Access Compliance Report

Public Rights-of-Way

(Curb Ramps)

Intersection ID: 15676	Main Street: CHEROKEE_PL	Cross Street: CHEROKEE_RD	Location: NE
ADA ID: F1AFA283F492	Ramp Type: PerpDiag	Initial Pass/Fail: Fail	Overall Compliance: No
		Severity Score: 10

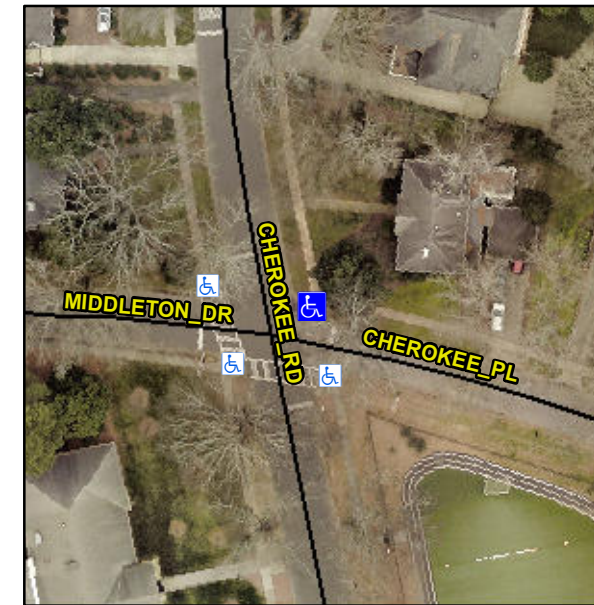
R304.5.1, R304.5.3

Compliance	Description	Data	Compliance	Description	Data
N/A	Ramp Length (in)	86.0	Yes	Ramp Slope (%)	7.3
No	Ramp Width (in)	44.5	No	Ramp XSlope (%)	3.1
N/A	Flare Type LT	N/A	N/A	Flare Type RT	N/A
N/A	Flare Slope LT (%)	N/A	N/A	Flare Slope RT (%)	N/A
N/A	Flare Traversable LT?	N/A	N/A	Flare Traversable RT?	N/A
N/A	Landing Length (in)	N/A	N/A	DWS Provided?	N/A
N/A	Landing Width (in)	N/A	N/A	DWS Contrast?	N/A
N/A	Landing Slope (%)	N/A	N/A	DWS Length (in)	N/A
N/A	Landing X Slope (%)	N/A	N/A	DWS Full Width?	N/A
N/A	Landing Curb? (Y/N)	N/A	N/A	DWS Offset (in)	N/A
N/A	Shared Landing?	N/A			
N/A	Gutter Ponding?	Yes	N/A	Gutter Slope (%)	N/A
N/A	Gutter Lip Ht (in)	N/A	N/A	Gutter X Slope (%)	N/A
N/A	Painted X Walk1?	No	N/A	Painted X Walk2?	No
	X Walk 1 Direction	To NW		X Walk 2 Direction	To S
N/A	X Walk 1 Width (in)	N/A	N/A	X Walk 2 Width (in)	N/A
	X Walk 1 Slope (%)	4.7		X Walk 2 Slope (%)	1.1
	X Walk 1 X Slope (%)	1.4		X Walk 2 X Slope (%)	1.0

Remove & Replace Curb Ramp With Two New Directional Ramps or Equivalent.
